STATE OF OHIO
DEPARTMENT OF TRANSPORTATION
HUR-CR 11-2.96
BASELINE ROAD/BROADWAY ST.
VILLAGE OF PLYMOUTH
HURON COUNTY
RICHLAND COUNTY

REPLACEMENT OF A DETERIORATED WOOD BEAM BRIDGE OVER ASHLAND RAILWAY IN VILLAGE OF PLYMOUTH ON EXISTING HORIZONTAL ALIGNMENT AND MODIFIED VERTICAL ALIGNMENT WITH APPROACH ROADWAY WORK.

ADDENDUM 1

SCHEMATIC PLAN/PROJECT SITE PLAN
 STA. 149+50.00 TO STA. 163+46.88

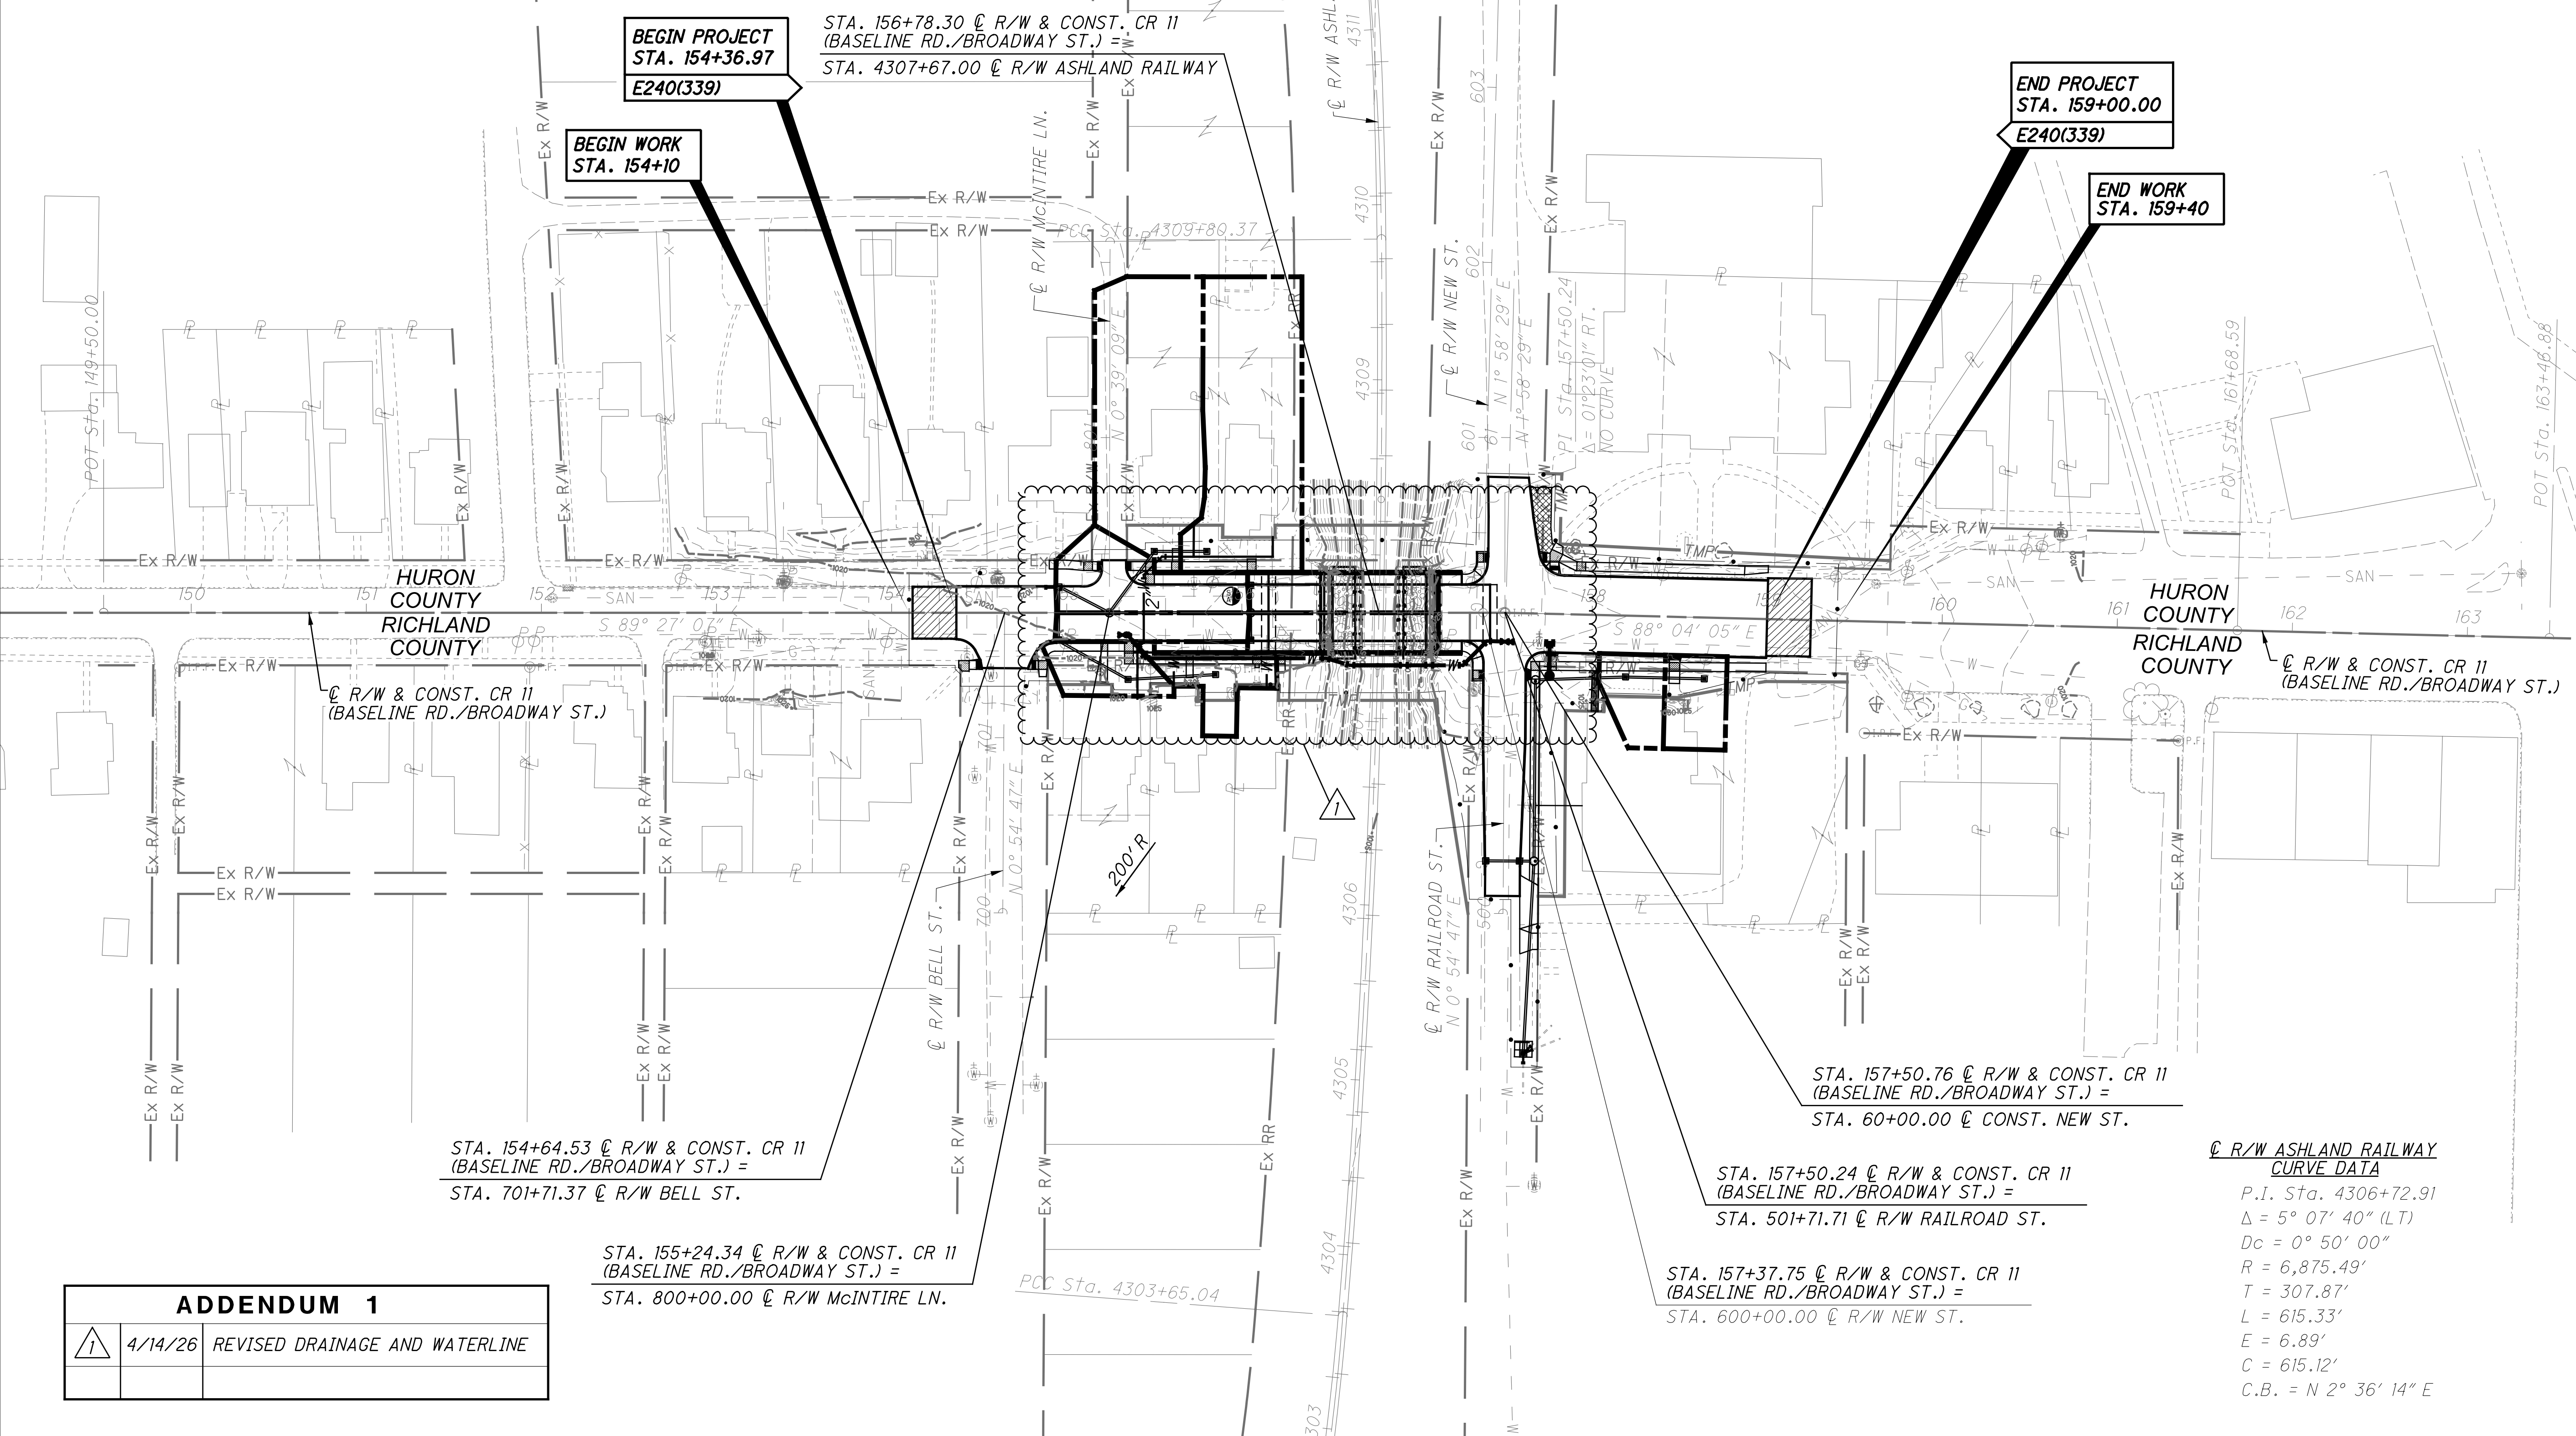
| 1 | 4/14/26 | REVISED DRAINAGE AND WATERLINE |

PLAN AND PROFILE
 STA. 158+00.0 TO STA. 163+00.00

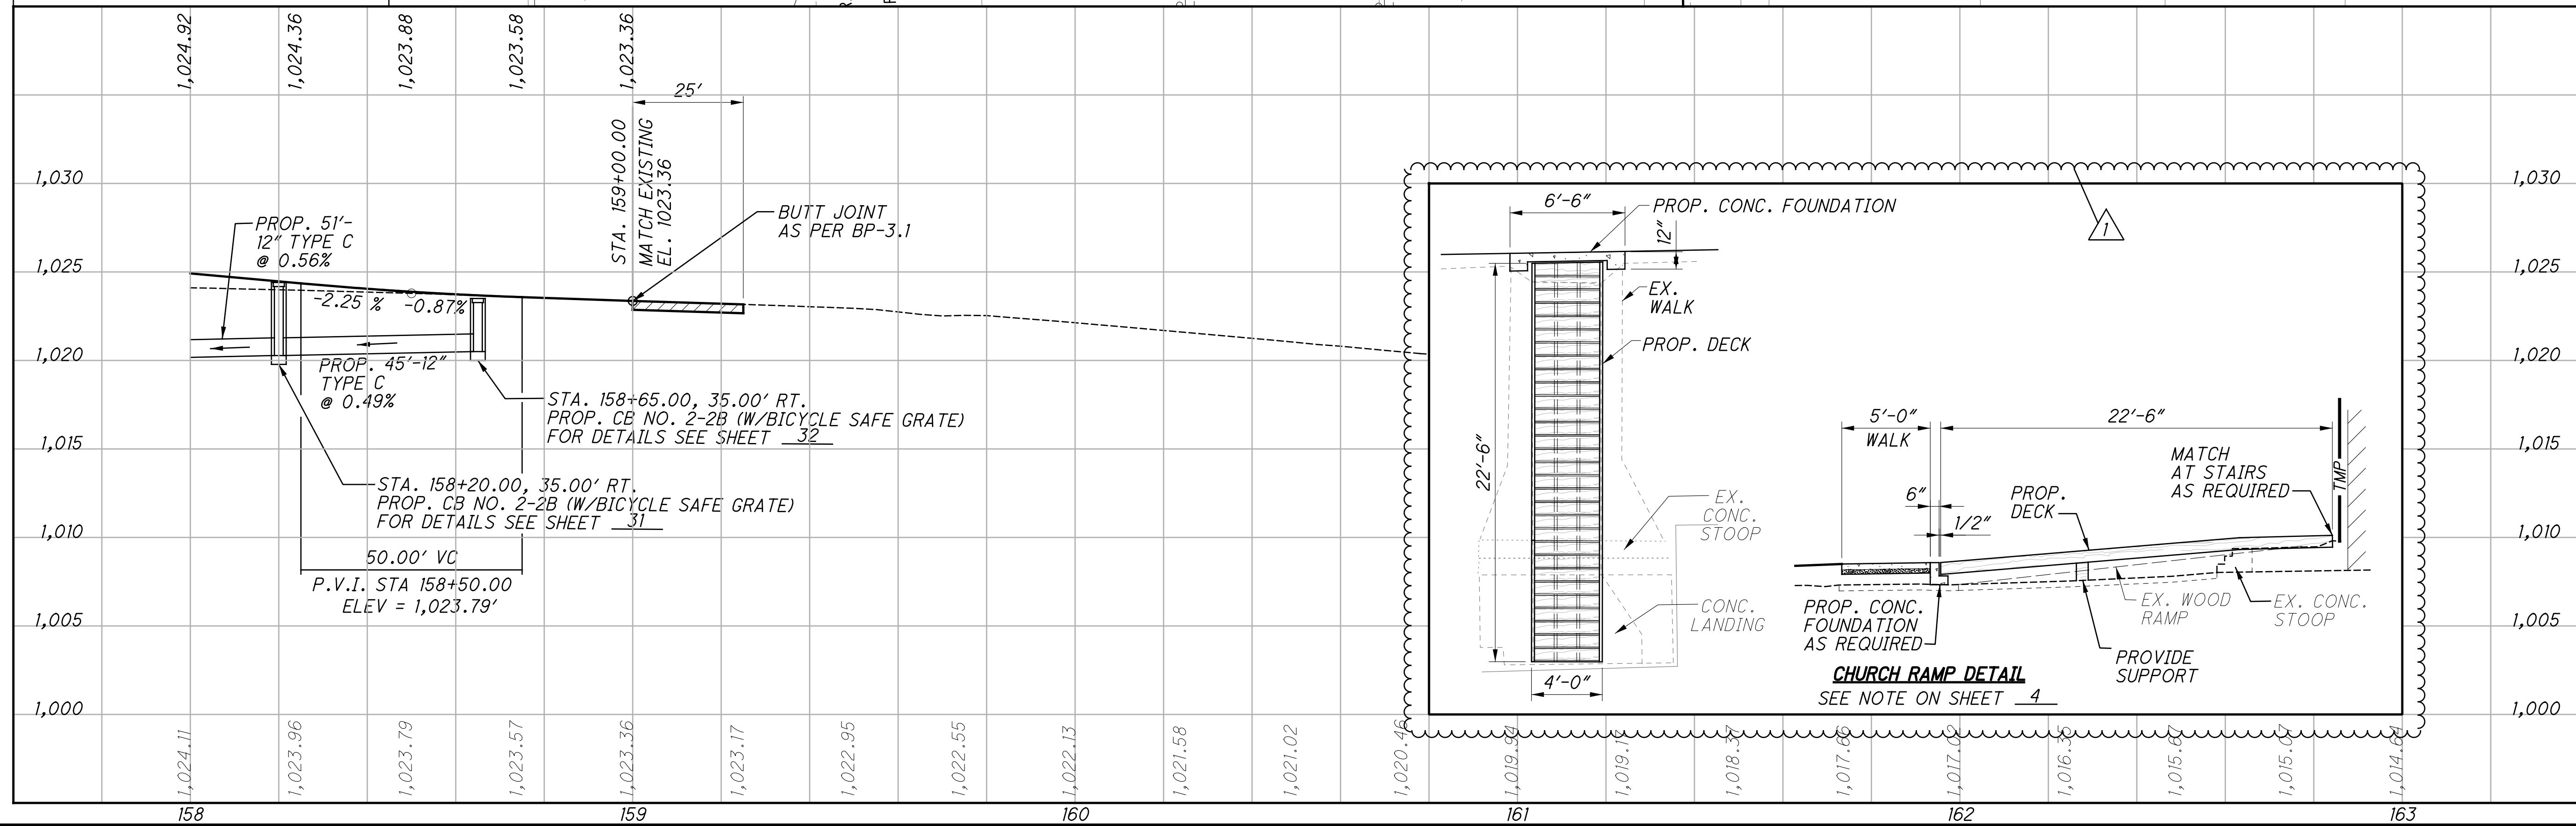
| 4/14/26 | REVISE RAMP DETAIL |

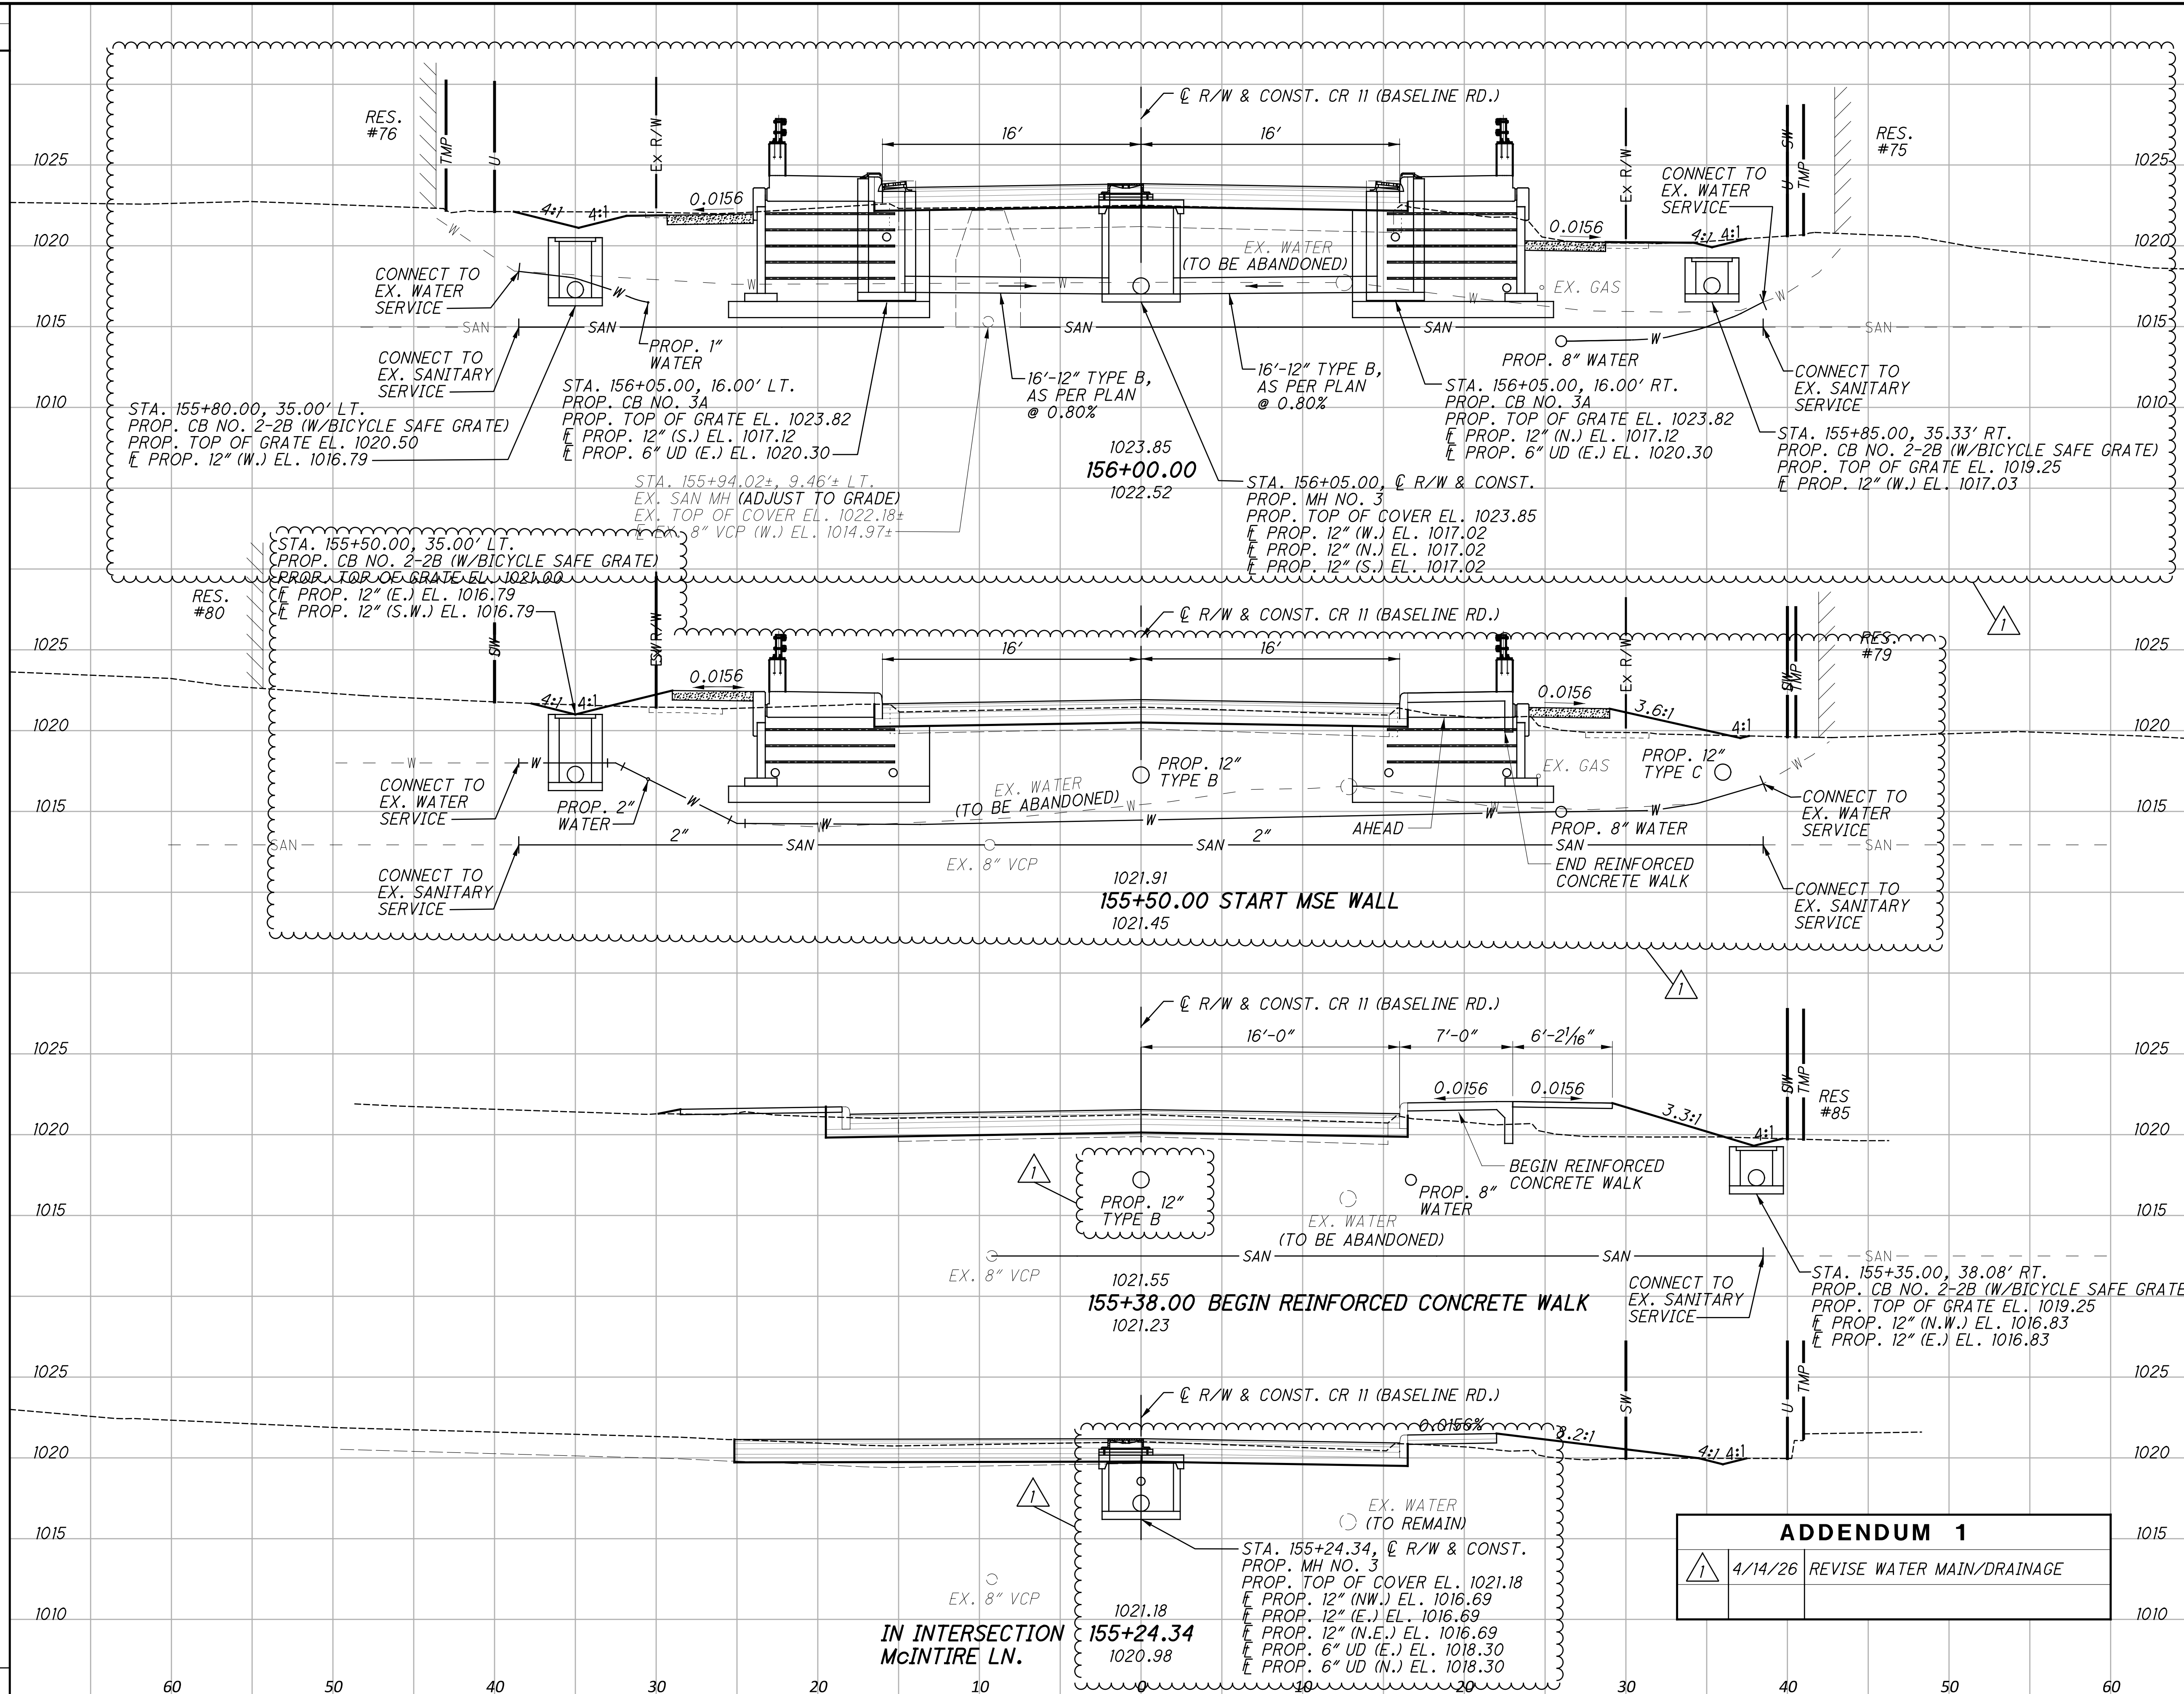
| ADDENDUM 1 | | |
|------------|---------|----------------------------|
| 1 | 4/14/26 | REVISE WATER MAIN/DRAINAGE |
